TOWN OF CARMEL
ENVIRONMENTAL CONSERVATION BOARD

ENVIRONMENTAL CONSERVATION BOARD AGENDA

Frank Cioffi
436 Austin Rd
TM-64.5-1-48

ECB Requirements for 2nd meeting

CONSTRUCTION PERIOD PART PLAN

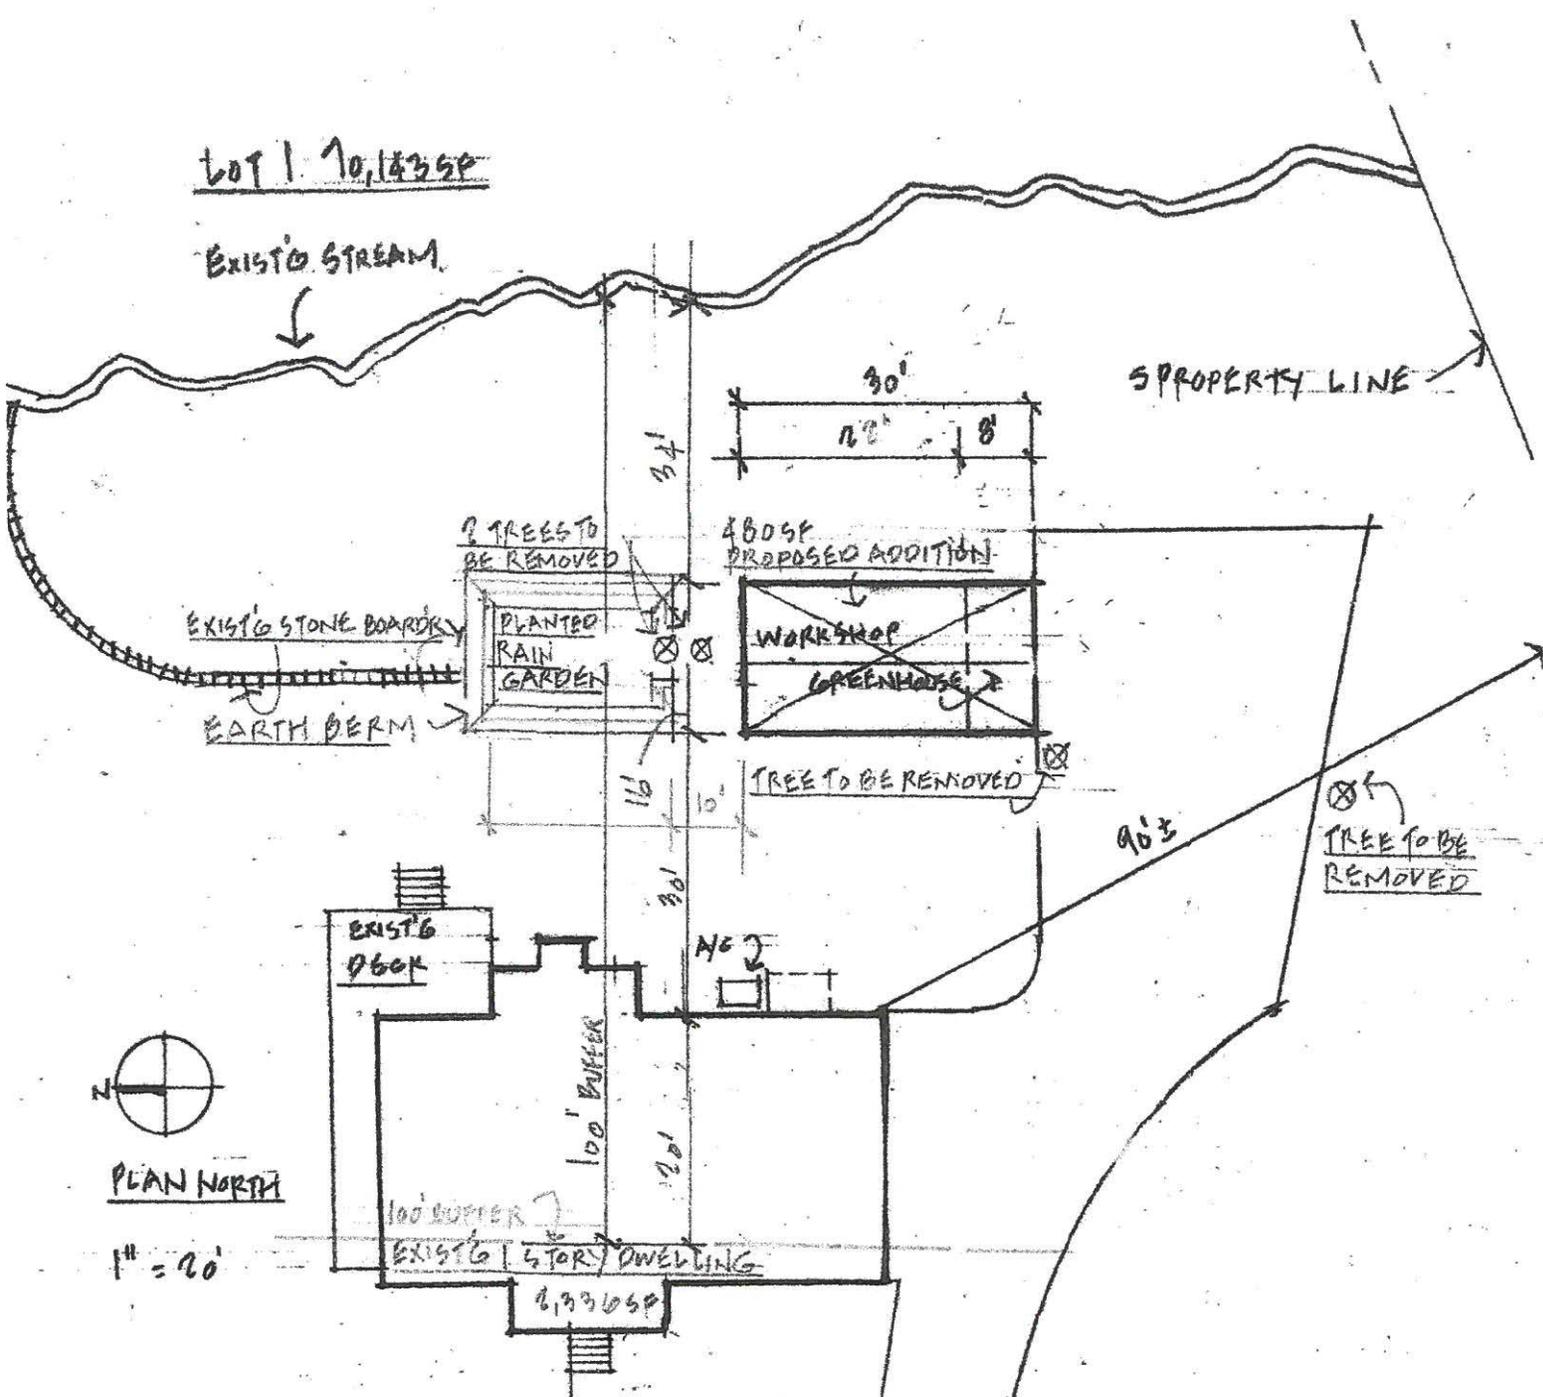
Show line of buffer which is 100 ft from stream (In this case the line will be drawn thru the house).

Show a trench for electrical service.

Detail silt fence

Layout for rain garden. I have instructions for this.

Location of stockpile(from excavation). Cover with tarp.

If excavating by machine, show location of overnight storage outside of the buffer. Include spill kit info and tarp under machine.

Sequence of work.

The stream is underground until it enters my property at the south border where it come to daylight thru a large black culvert pipe. Let's notate that on the plan.
